**GOVERNMENT OF THE DISTRICT OF COLUMBIA
DEPARTMENT OF TRANSPORTATION**

MEMORANDUM

SUBJECT: **BZA Case No. 19823** - 3920 Alton Place NW (Wisconsin Avenue Baptist Church)

Figure 1 – Site Plan (Source: Applicant’s Architectural Plans and Elevations, Exhibit 6A1, dated June 14, 2018)

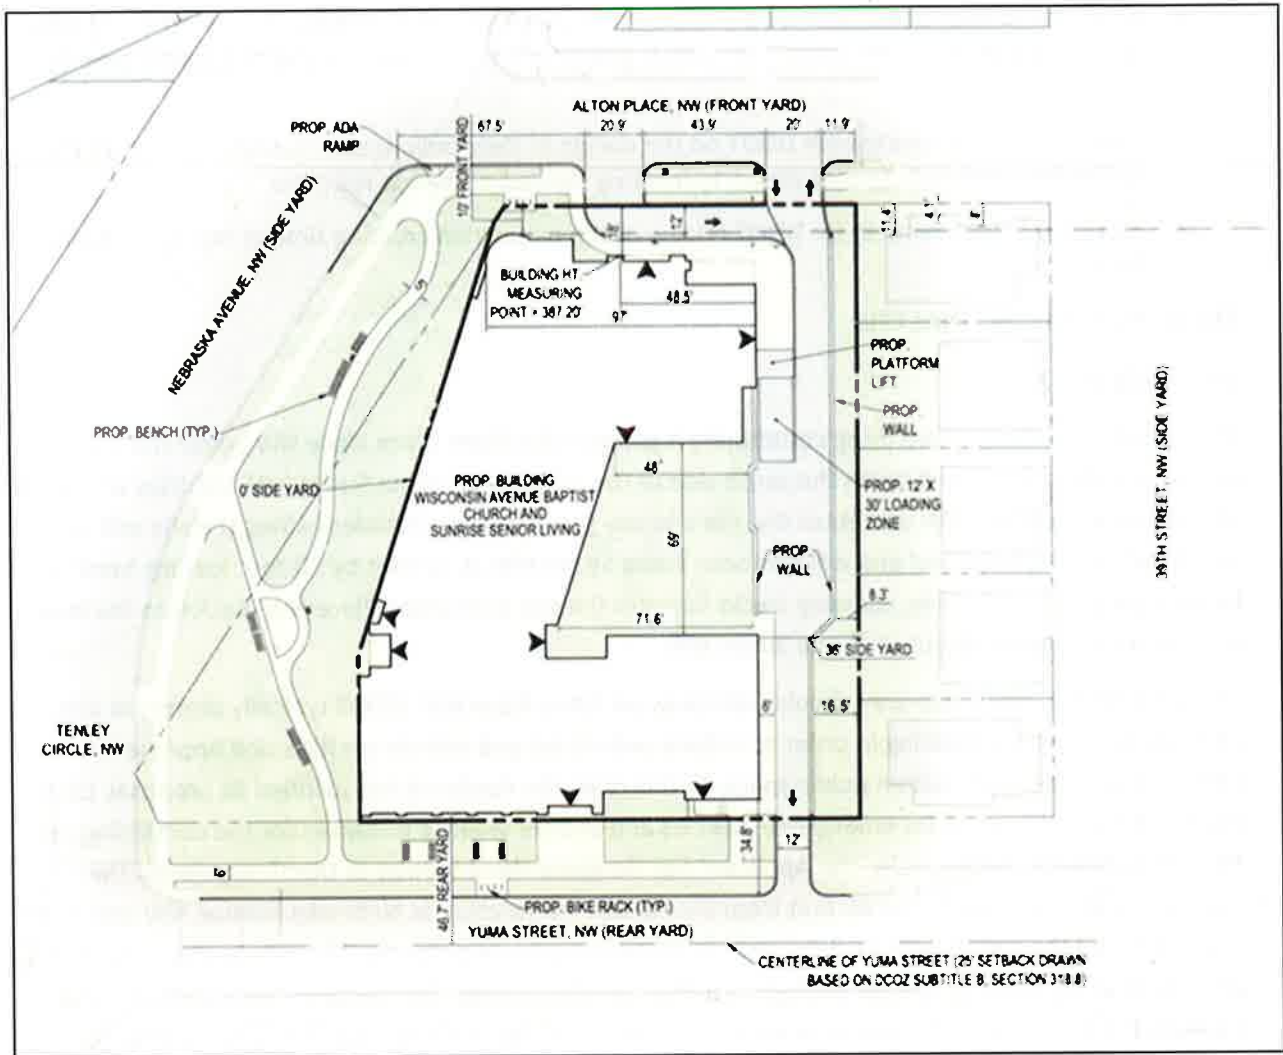
- The Applicant proposes to meet its loading requirements by supplying a 20-foot long service and delivery space internal to the garage and a 30-foot loading berth parallel to the site's proposed driveway (see Figure 1). The design of the site allows all backing maneuvers to occur within private space. The Applicant has also proposed a Loading Management Plan (LMP) to help facilitate trucks to and from the site;

The entrance to the assisted living community is proposed to front Alton Place NW, while the main entrance to the church will be on the south side of the building on Yuma Street NW. Vehicles will enter the site on Alton Place NW and enter the site's below grade garage. Vehicles exiting the site will turn south out of the garage and will exit onto Yuma Street NW. A 12-foot by 30-foot loading berth is located parallel to driveway, allowing trucks to enter the site onto Alton Place NW, back into the loading area, and proceed head-out on Yuma Street NW.

The site also includes a one-way circular driveway on Alton Place NW. DDOT typically prefers to allow only one curb cut per building in order to reduce pedestrian and vehicle conflicts and improve pedestrians' experience within public space. In this case, the Applicant has justified its proposal, citing the need for rapid access for emergency vehicles and shorter walking distances for the continuing care facility's residents. Additionally, the Applicant has designed the driveway to DDOT standards. The driveway maintains more than 60 feet from the closest intersection at Nebraska Avenue NW and Alton Place NW and the entirety of the drive aisle is located on private property. The aisle is also proposed to be 12 feet wide, which is narrow enough to inhibit vehicle parking. The western curb cut on the site exceeds DDOT standards for one-way access, but has been designed in a manner to accommodate the turning sweep of the anticipated operator's shuttle bus. The Applicant has agreed to revise the circular driveway's island to add additional landscaped space and will coordinate further with DDOT on the design of the curb cut during the public space permitting process (See Figure 2). The proposed site plan is shown in Figure 1 below.

Figure 2 – Western Curb Cut Evaluation (Source: Gorove/Slade Associates, Inc.)

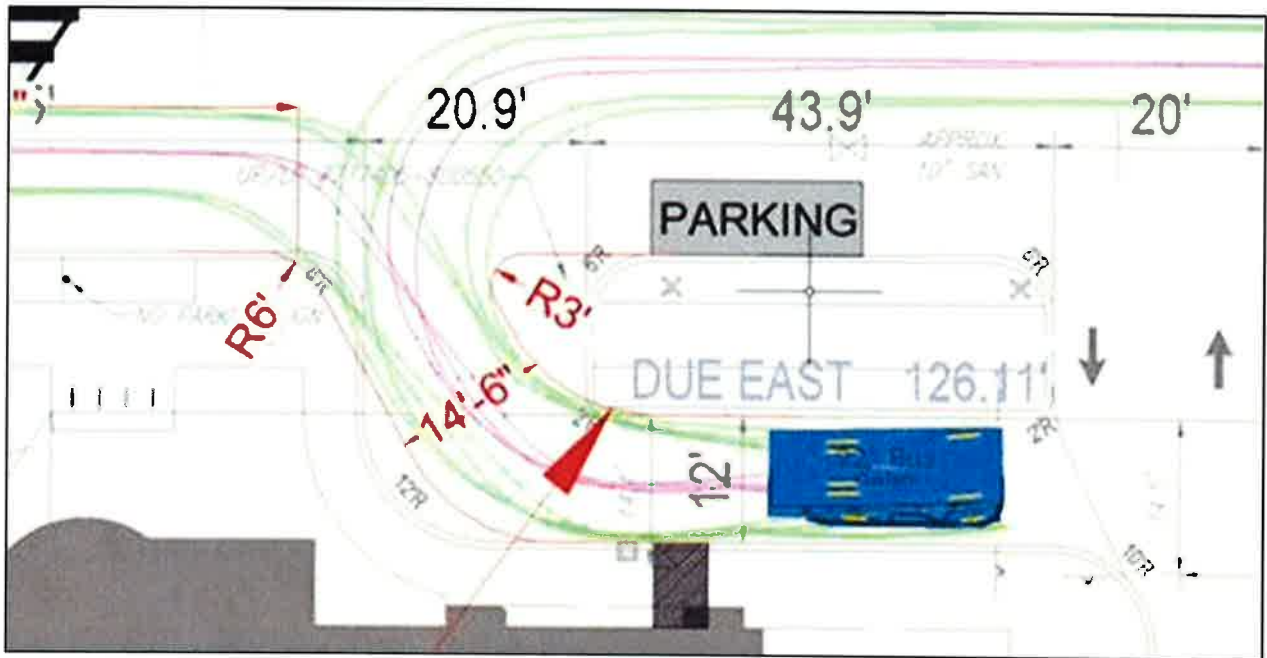
DDOT notes that the Applicant has agreed to coordinate further on the design of the circular driveway's western curb cut. A conceptual drawing of a potential revision follows in Figure 2 below. As shown in the diagram, additional landscaping on the eastern side of the curb cut will require the Applicant to increase

the radius on the western side, or shuttles will need to swing into the opposing travel lane in order to make the turn. The design will be further assessed during the public space permitting process.

- Continue to coordinate with DDOT through the public space permitting process to ensure that the landscape island on Alton Place NW is extended to the maximum intent possible (see Figure 2);
- Continue to coordinate with DDOT on the design of the public space, including the area adjacent to the National Park Service property fronting Nebraska Avenue NW; and
- Submit a formal request for DDOT review of the pedestrian crossing time at Nebraska Avenue NW.
